REDWAY TRANSFER STATION IMPROVEMENTS CONTRACT NO.: 438005

County of Humboldt
Department of Public Works
1106 Second Street
Eureka, CA 95501
TEL (707) 445-7377
ADDENDUM NO. 1
(Issued September 26, 2025)

County of Humboldt
Department of Public Works
1106 Second Street
Eureka, CA 95501
TEL (707) 445-7377
ADDENDUM NO. 2
 (Issued September 30, 2025)

County of Humboldt
Department of Public Works
1106 Second Street
Eureka, CA 95501
TEL (707) 445-7377
ADDENDUM NO. 3
 (Issued October 3, 2025)

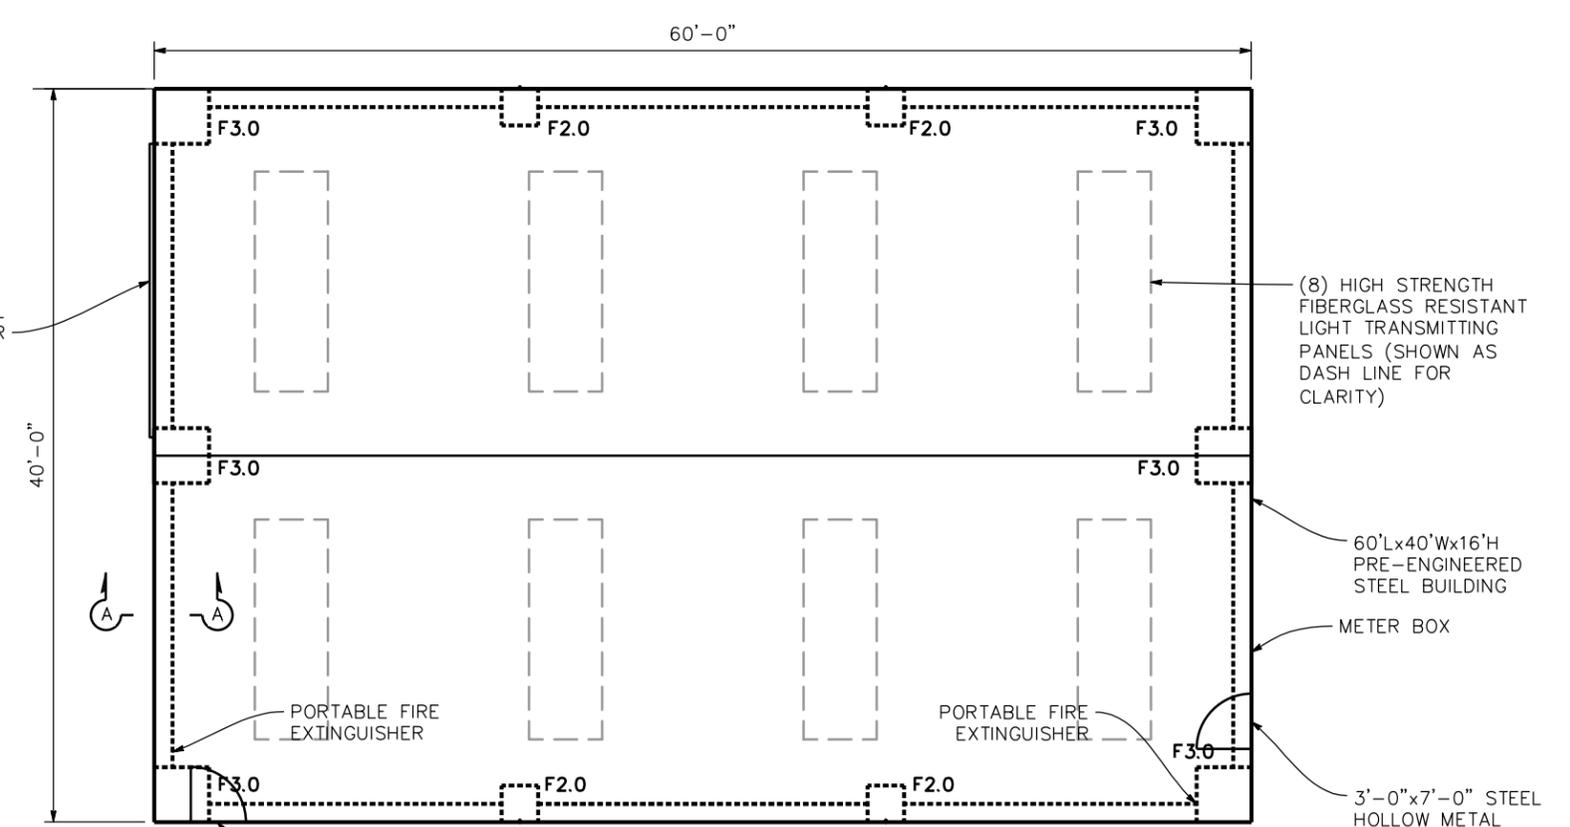
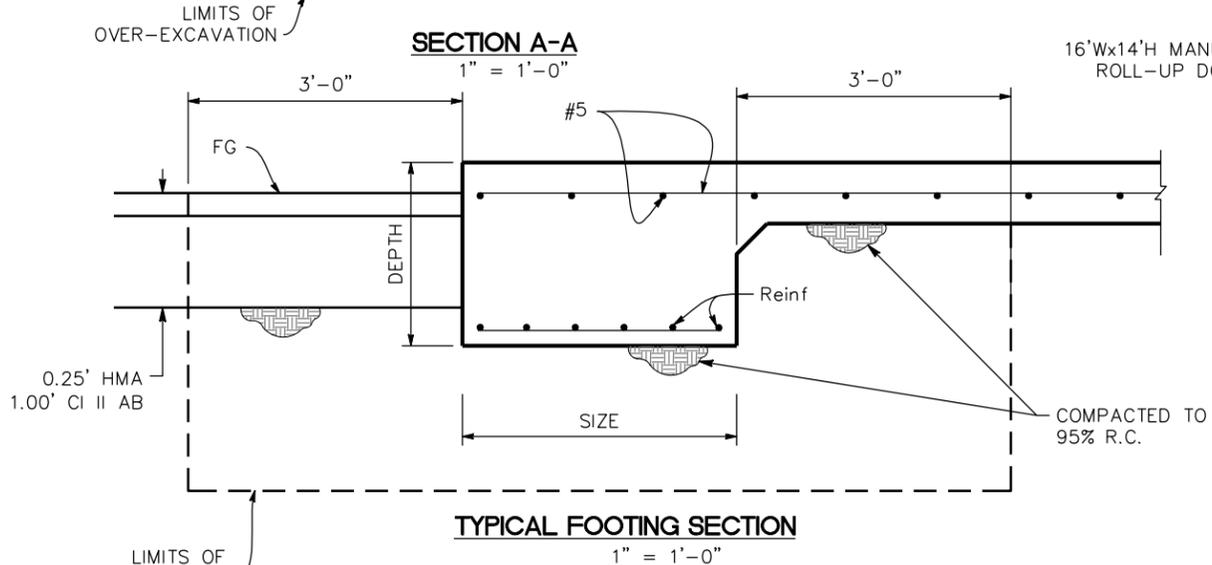
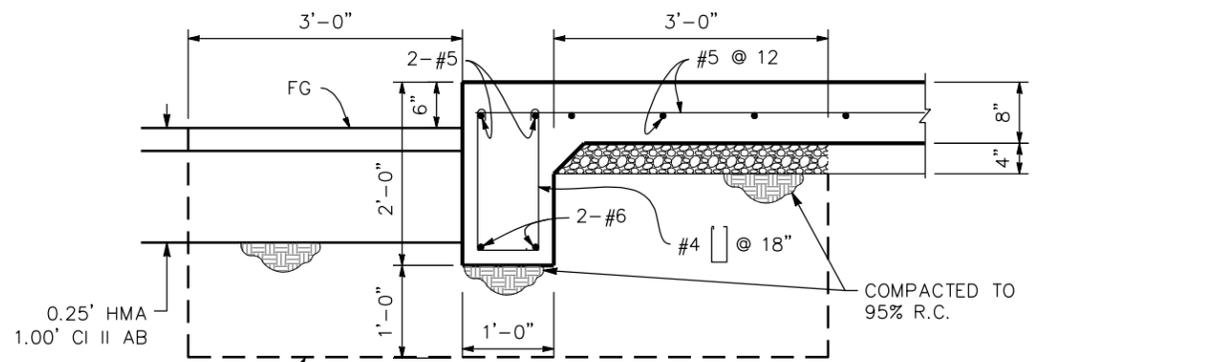
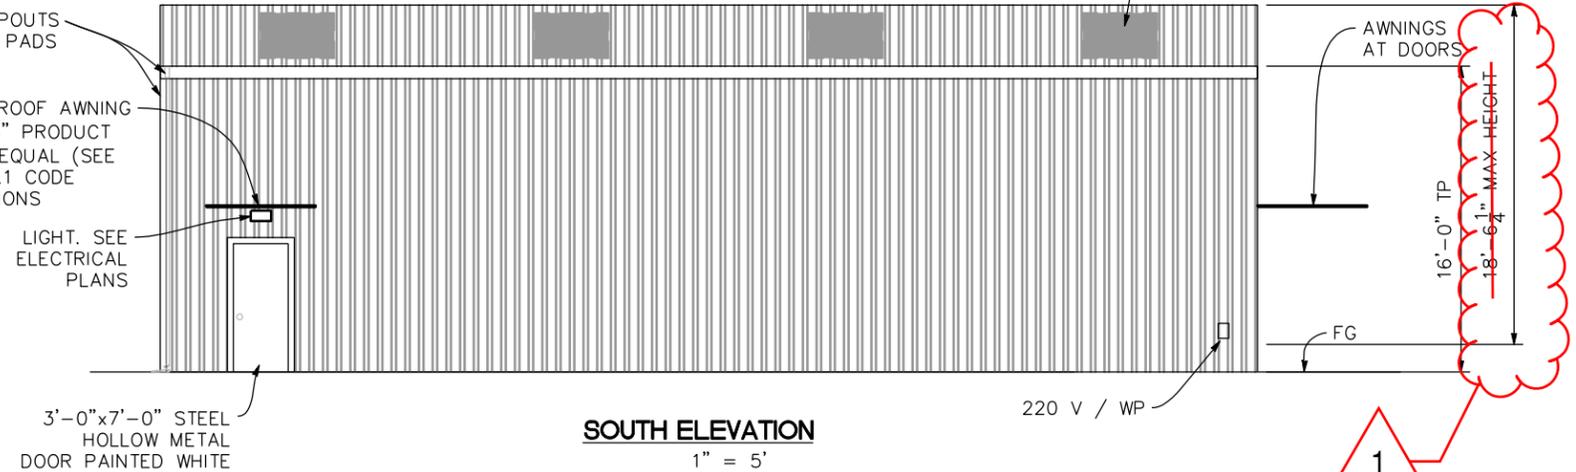
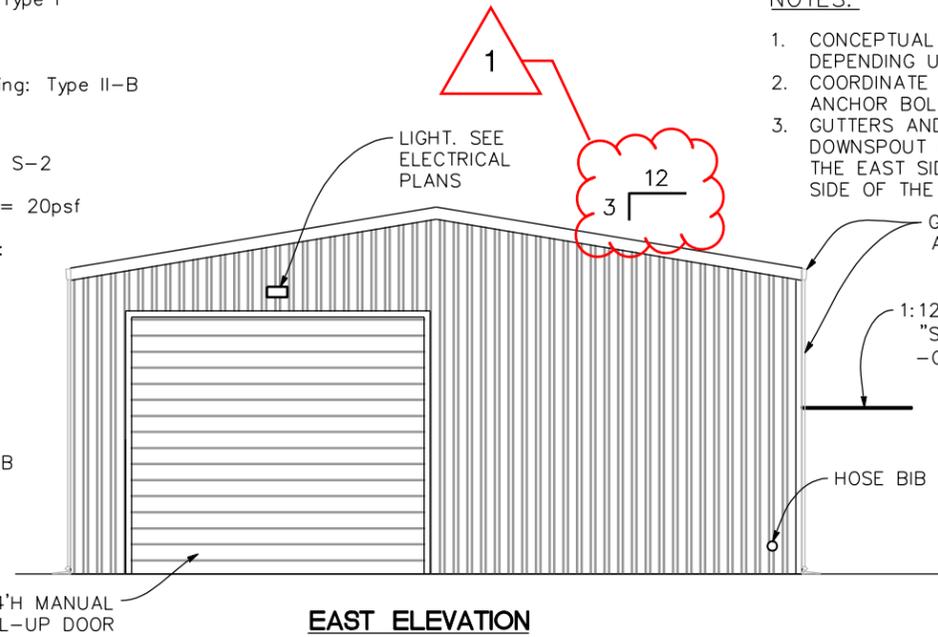
1. Replace Sheet 44 of 58 of the project plans with the attached revised sheet 44 (Attachment 1).
2. In the Supplemental Project Information table in section 2-1.06 B of the special provisions, replace bullet point 6, "Weigh Scale – Ricke Lake Weiging Systems, INC – AMERICAN SCALE Quotation_August 13, 2025" with "Weigh Scale – Rice Lake Weighing Systems_Redacted". This revised supplemental information will be uploaded to the county website at <https://humboldt.gov/bids.aspx?bidID=622> under "Related Documents".
3. Replace Section 99-3.02 with the following:

Question 2: Is there a specific roofing profile and roof pitch for the metal building?
Answer: <i>Yes. 3:12 pitch standing seam. See attachment 1, which shows a revised sheet 44 of the plans.</i>

REVISED ROOF PITCH AND ELIMINATED DIMENSION
